November 12, 2018
BOARD OF COUNTY COMMISSIONERS
ORANGE COUNTY, FLORIDA
Y19-709-CH / ADDENDUM # 1
WESTERN REGIONAL WATER SUPPLY FACILITY IMPROVEMENTS PHASE 3B

Y19-709-CH:
Addendum #1
November 12, 2018

C302

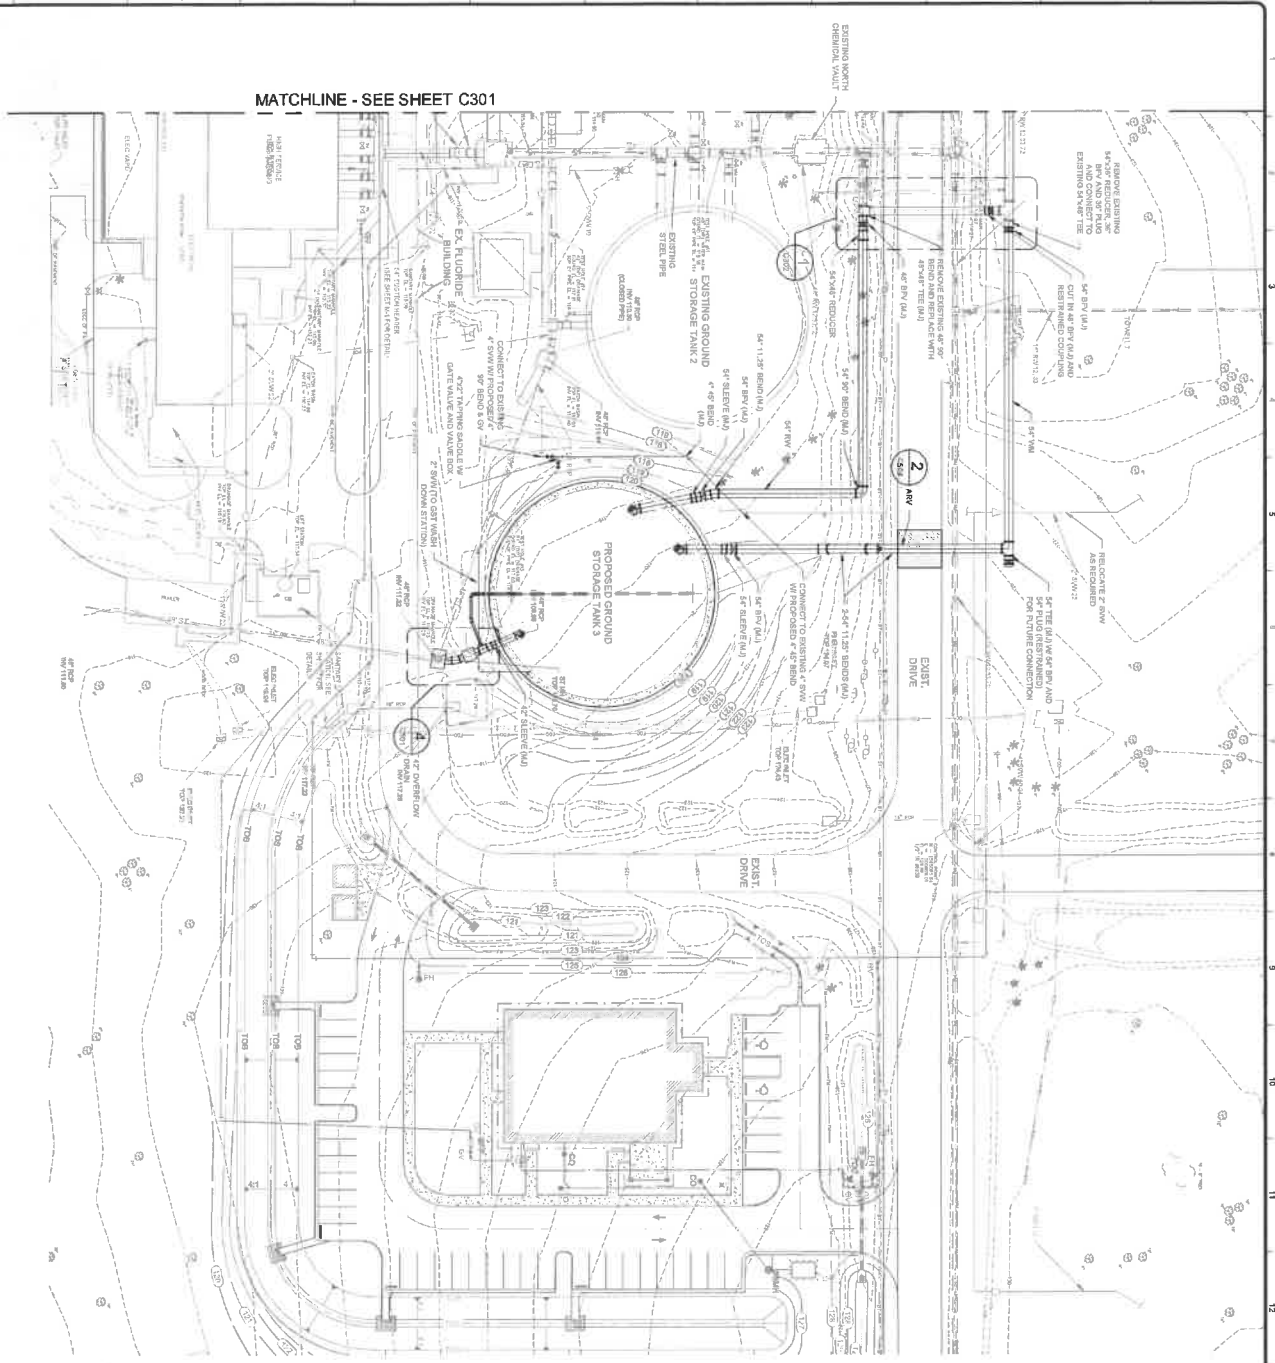
6. Q: Please provide existing site pipe demolition drawings for existing water main line.

- A: **If bid opening remains November 20, 2018, the second business day will be Monday November 26, 2018.**
10. Q: Please provide civil detail of cut in section of 48" WM as shown on C302.

- 1. Drawing Sheet C302, Replace Drawing Sheet C302 Utility Plan with the attached Drawing Sheet C302 Utility Plan included in Addendum #1.**

- REMOVE EXISTING 48" SCH 40 90° BEND
- REMOVE PORTION OF EXISTING PIPING FOR RESTRAINED CONNECTION
- REMOVE EXISTING 48" SCH 40 90° BEND
- REMOVE EXISTING 48" SCH 40 90° BEND

A: Existing raw water piping details have been included. See revisions to Drawing C302 below in Part C of this addendum.

- A: **The indicated section of the existing 48" DIP is to be cut and removed for the installation of the new 48" BFV (MJ) and Restrained Coupling. Revised C302 shows this detail.**
